**NUMBER:** 18-010-17

Engine Oil Viscosity Upgrade And Flash Enhancements

2016 (WK) Jeep Grand Cherokee 2016 (DS) RAM 1500 Pickup

Fig. 1 Cap Before Sticker Applied

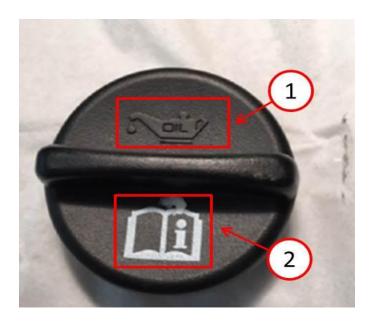
- 5. Run engine for 10 minutes before oil change to warm up the engine oil.
- 6. Remove oil fill cap.
- 7. Clean top of oil fill cap with Isopropyl alcohol or equivalent and apply engine oil viscosity rating sticker as shown in (Fig. 1).

- 1 Do Not Cover This Embossed International Oil Symbol
- 2 Cover This Old Oil Info Symbol With The New "5W40" Label
- 8. Remove the oil drain plug and allow oil to drain for at least 5 minutes or until it stops dripping.

Fig. 2 Damaged Rubber Seal

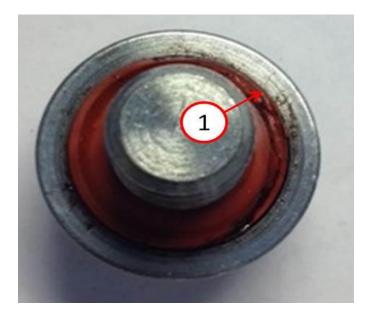
9. Inspect the oil drain plug and gasket for damages (Fig. 2). Replace if necessary.

1 - Oil Drain Plug Gasket Seal Crushed
